Application Serial No.: 09/850,206
Filing Date: May 7, 2001
Docket No.: 1100-113
Page 7

Remarks/Arguments:

Amendments to the Drawings:

FIG. 21

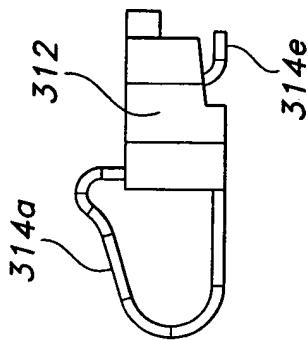
Additionally, with reference to claim 6, the Examiner asserts that the contact free end within the housing must be shown or the feature(s) canceled from the claim. The contact free end, 314C is now shown in Fig. 21 and the structure of the contact and manner in which its end is within the housing is clearly described on page 13, lines 15-17.

In Fig.21, reference numeral 314c has been included to show the contact free end. The support for the contact free end 314c is described on page 13, lines15-17.
